Proposal for Supplement 3 to the 03 series of amendments to UN Regulation No. 129 (Enhanced Child Restraint Systems)

Submitted by the experts from the Working Party on Passive Safety*

Supplement 3 the 03 series of amendments to UN Regulation No. 129 (Enhanced Child Restraint Systems)

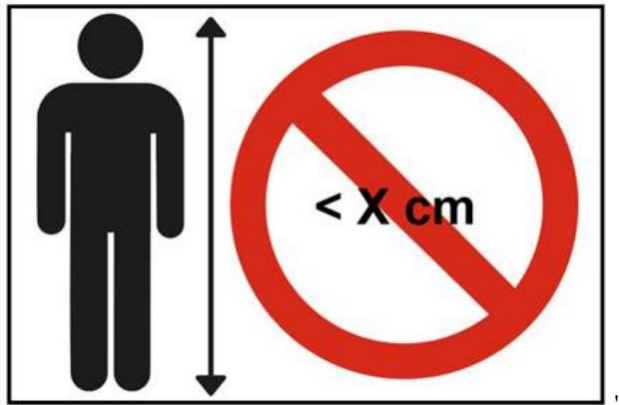
- 4.8.4. Specific vehicle booster cushion Enhanced Child Restraint Systems (except built-in) shall have a permanently attached label with the following information visible to the person installing the Enhanced Child Restraint System in the car:

- 4.8.5. Booster cushion Enhanced Child Restraint Systems shall have the following label (Minimum size: 60 x 40 mm) permanently attached and visible to the person installing the Enhanced Child Restraint System in the car. The limit X shown on the label represents the lower stature of the size range the Enhanced Child Restraint System is approved to. If the booster cushion is approved in combination with a booster seat the label shall be visible only when the ECRS is used as a booster cushion.

Figure 1
Measurement device to check the Sitting Height

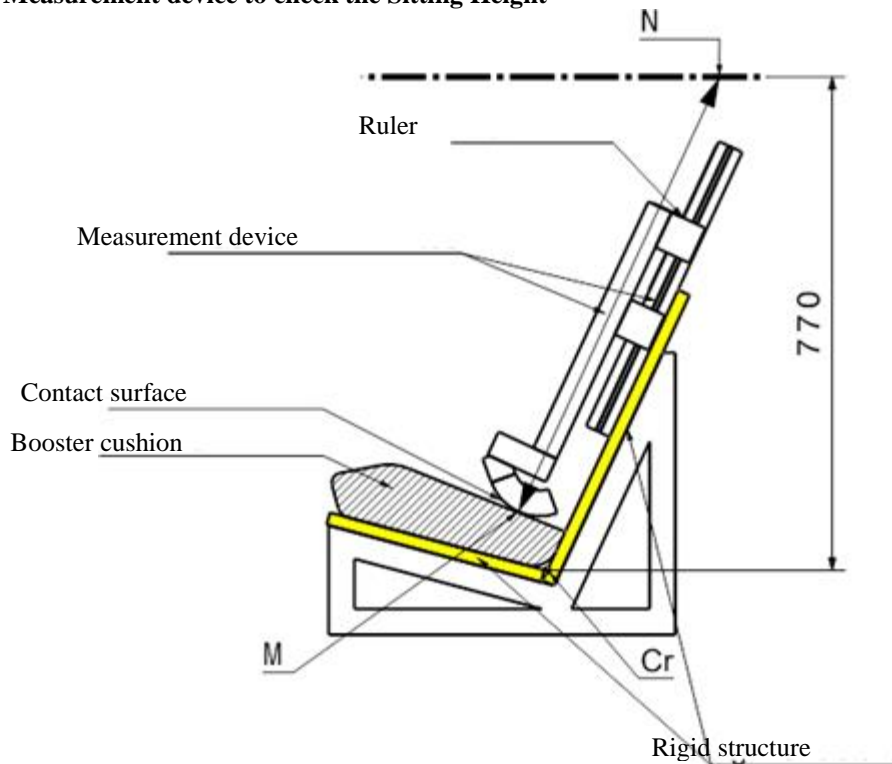
"6.1.3.6. For booster cushions, type approval shall not be granted for a stature below 125 cm. Booster cushions shall not be declared for use below a stature of 125 cm.

Booster cushions shall ensure that the top of the child's head is at or above a horizontal plane at 770 mm vertically from the Cr axis when seated on the test bench described in Annex 6.

The procedure to check if a booster cushion fulfils this requirement is outlined as follows (See figure 1 below):

- (a) A simulated test bench shall be used for the assessment. The simulated bench shall have the same geometry as the test bench defined in Annex 6 of this Regulation, including the seat cushions. However, the width of the simulated bench may be reduced, if the width is between 500 and 800 mm, as shown in Annex 25. The simulated test bench shall be of rigid construction and shall not deform when using the measuring device defined in Annex 25.

- (b) A rigid structure is attached to the simulated test bench and holds a sliding part. A horizontal plane that is located at a vertical distance of 770 mm from the Cr axis is defined.

- (c) The booster cushion shall be placed on the simulated test bench with its centreline aligned with the centreline of the test bench and the rear surface of the booster cushion contacting the backrest of the test bench.

- (d) If ISOFIX attachments are present these shall be latched with the test bench lower ISOFIX anchorages. An additional force of 135 +/-15N shall be applied in a plane parallel to the surface of the simulated test bench. The force shall be applied along the centreline of the Enhanced Child Restraint System and at a height of no more than 100 mm above the simulated test bench seat surface.

- (e) The measurement device is extended downwards parallel to the simulated test bench backrest, until it is stopped by the booster seat cushion.

Figure 2
Ruler of measurement device

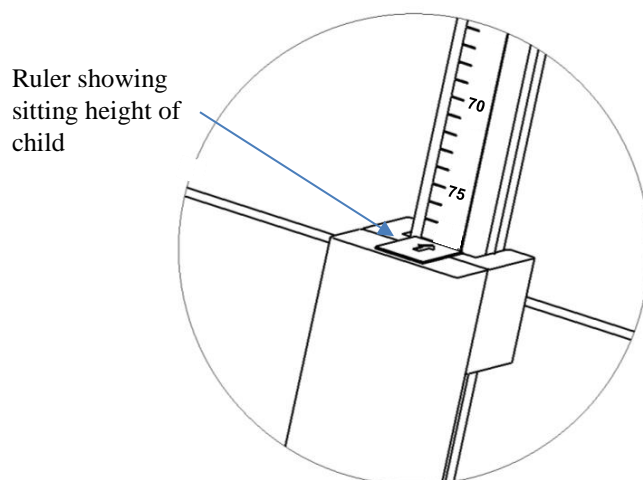
- (f) The measured distance between the two points M and N (Figure 1) represents the sitting height of a child who will use the booster cushion. The corresponding value is displayed by a ruler that is provided with the device as shown in Figure 2.
- (g) Using the data in Table 3, the sitting height is utilized to determine the corresponding minimum stature of the child that can be accommodated by the booster cushion. Example: A sitting height of 66.2 cm shall correspond to a child minimum stature of 125 cm; a sitting height of 75.9 cm shall correspond to 150 cm.

In case the value obtained for the sitting height is between two integer values always round up to the next integer value (e.g. Measured sitting height = 70.1 cm ► resulting stature = 135.65 cm ► Smallest stature allowed = 136 cm).

- (h) The stature determined in this procedure shall be compared to the lower limit of the approval stature range. The requirement is fulfilled if the lower approval stature is greater or equal than the obtained minimum stature.

Device to measure the booster cushion height

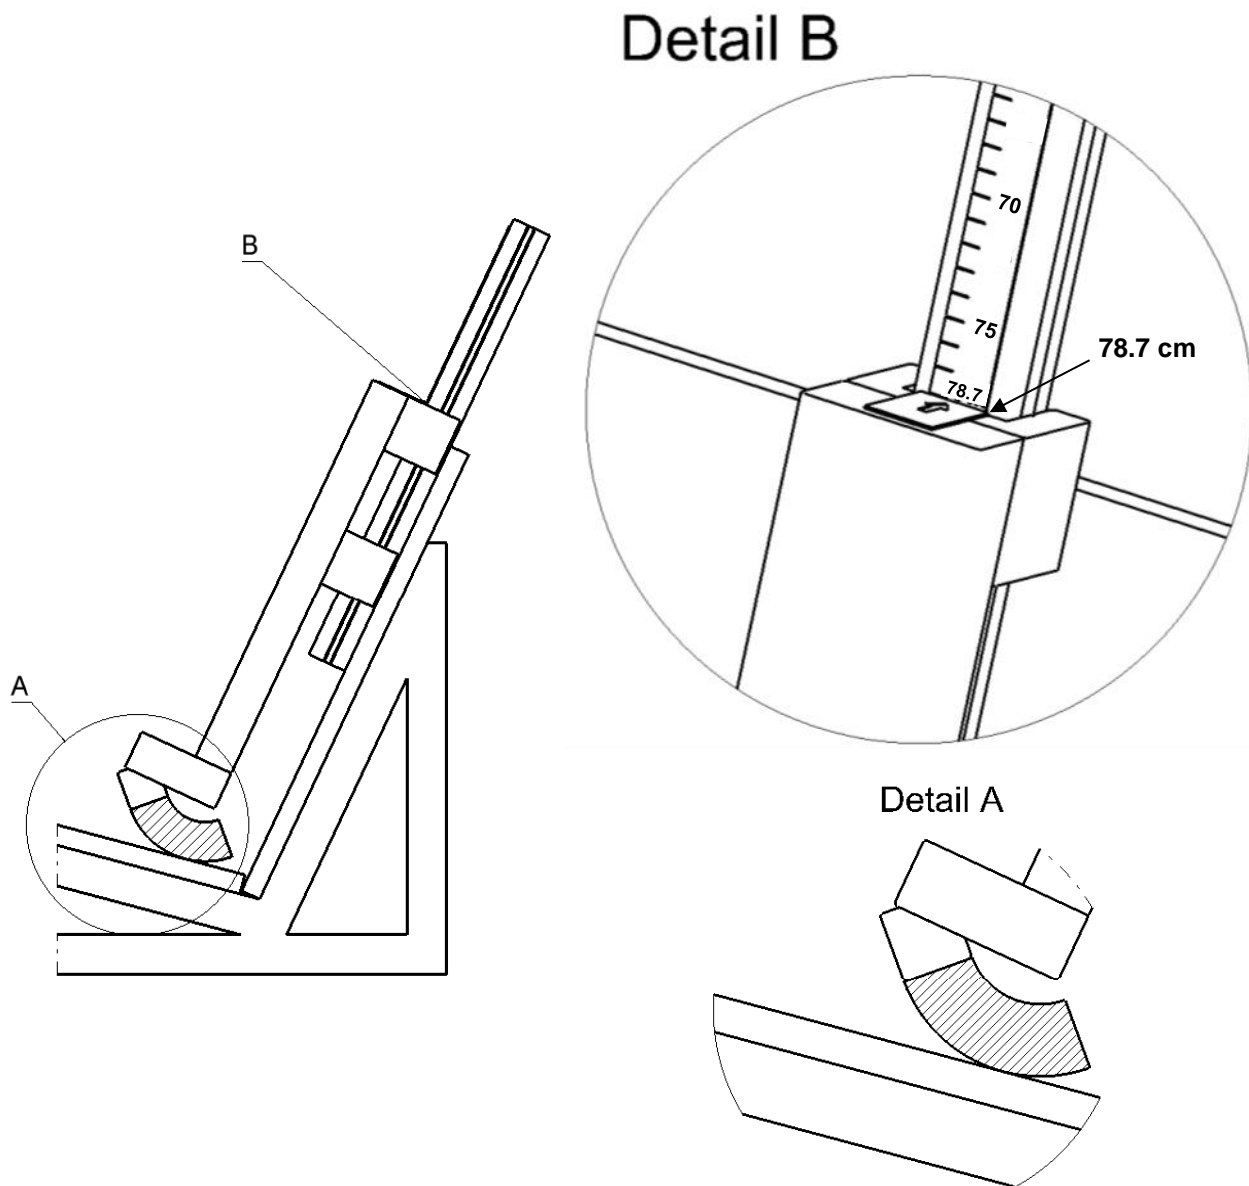
The mass of the device shall be 15kg +/-1kg

To calibrate the ruler of the measurement device, its structure shall contact the supporting surface (Detail A). In this configuration, the scale shall show the calibration value of 78.7 cm (Detail B).

The calibration of the ruler is based on the sitting height of the Hybrid III 5th percentile dummy seated on the test bench defined in Annex 6 of this Regulation. When this dummy is seated on the test bench, the top of the head is 77.0 cm from the Cr axis. The nominal sitting height of the dummy is 78.7 cm. Therefore, 78.7 cm is used as the calibration value.

Manikin block (based on truncated P10)

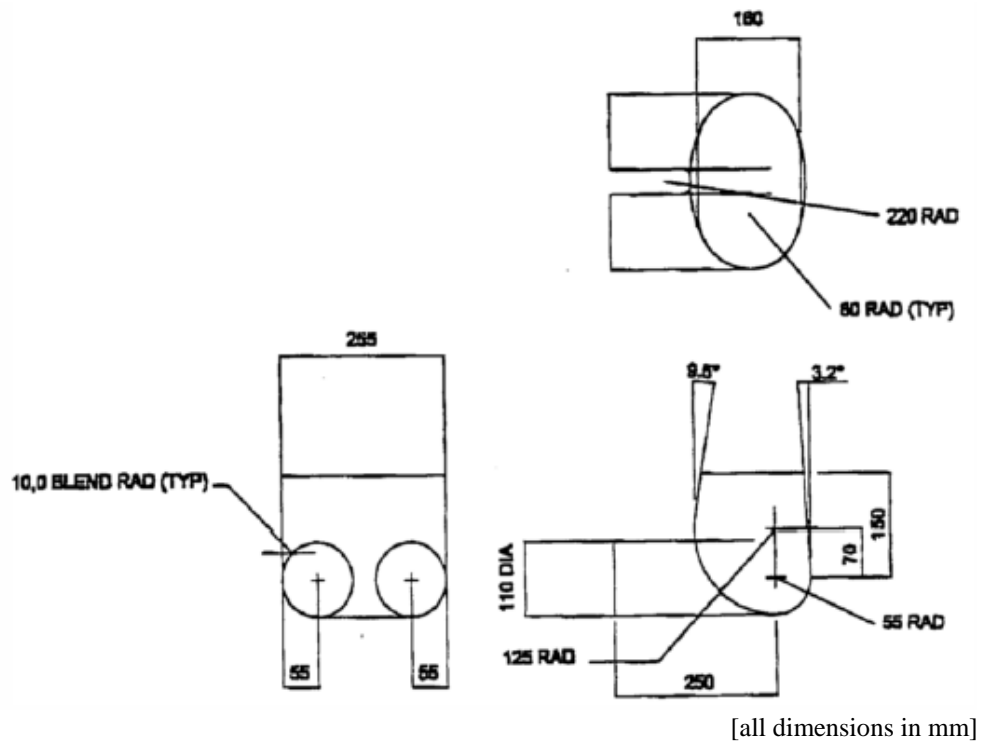
Place a cotton cloth on the seating surface of the test bench. Position the booster cushion on the test bench, position the lower torso body block as described in Annex 26, Figure 1, on the seating surface, fit and apply the 3-point adult safety-belt and tension as prescribed in paragraph 7.1.3.5.2.2. With a strip of 25 mm-wide webbing or similar, tied around the booster, apply a load of 250 ± 5 N in the direction of arrow A (see Annex 26, Figure 2), in line with the seating surface of the test bench.

Material: Expanded polystyrene (EPS) (40 to 45 g/l) or alternative non-deformable material

Booster pull test using manikin block

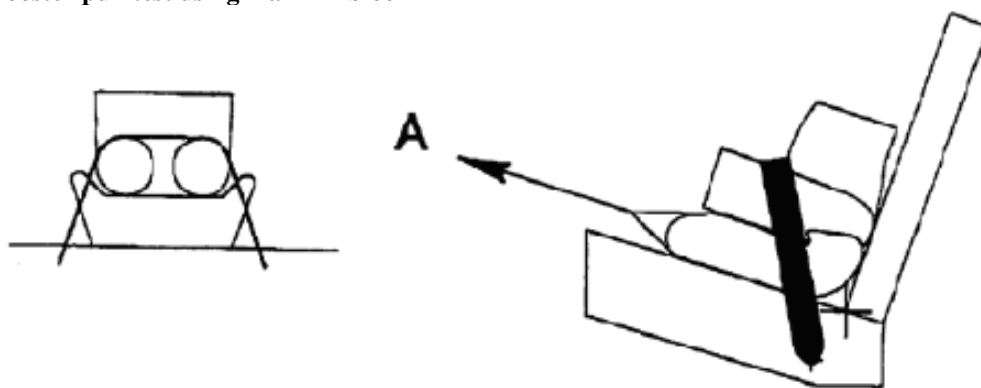
The booster cushion shall not be pulled completely out of the 3-point adult safety-belt and shall remain under the body block during the test."
